## WARNER GEAR TRANSMISSION DIPSTICK OIL LEVEL MARKING CHANGE

*(Attach Bulletin Reference Sticker to P. 6D-1 of Your Service Manual.)*

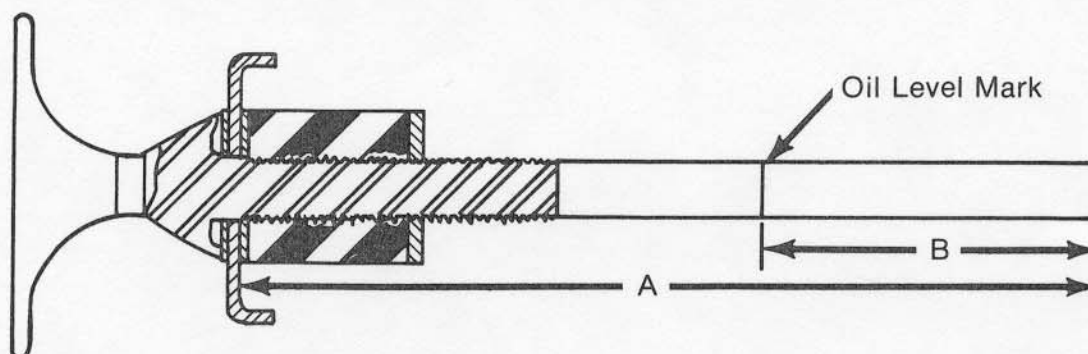
The low oil level mark has been removed from all Velvet Drive Marine Transmission dipsticks. A single mark on the dipstick indicates level at which the oil should be maintained. See illustration, below.

Three dipstick assemblies are involved in this change: Dipstick 10-04-559-001 is used in all 71C and 72C reduction units. Use dipstick 10-13-559-001 in all 71C and 72C direct drive units. Dipstick 10-06-559-001 is used on all "V" drive units.

The approximate distance from end of dipstick to the underside of the cap (dimension "A") and from end of dipstick to the oil level mark (dimension "B") are charted below. These dimensions will help identify each dipstick.
